Product Change Notification

PCN-027_2023_1-OMTS22004T0&S22004T

Production location change

HXS series – UPDATE with deadlines (see on page 4)

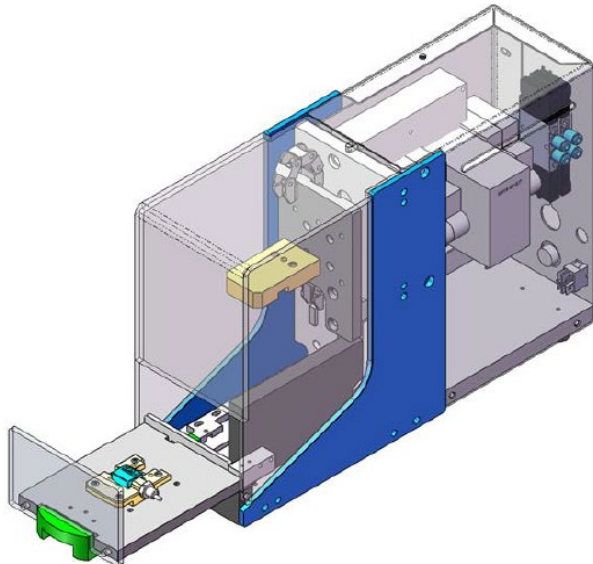
Step 1: At current LEM production center LEM Bulgaria (Sofia), the current assembly press will be replaced by a new assembly press (PLC, Laser, Cylinders) leading to better visual render laser marking (details as follows):

Leading to a better visual render for the marking as follows:

Old laser marking

New laser marking
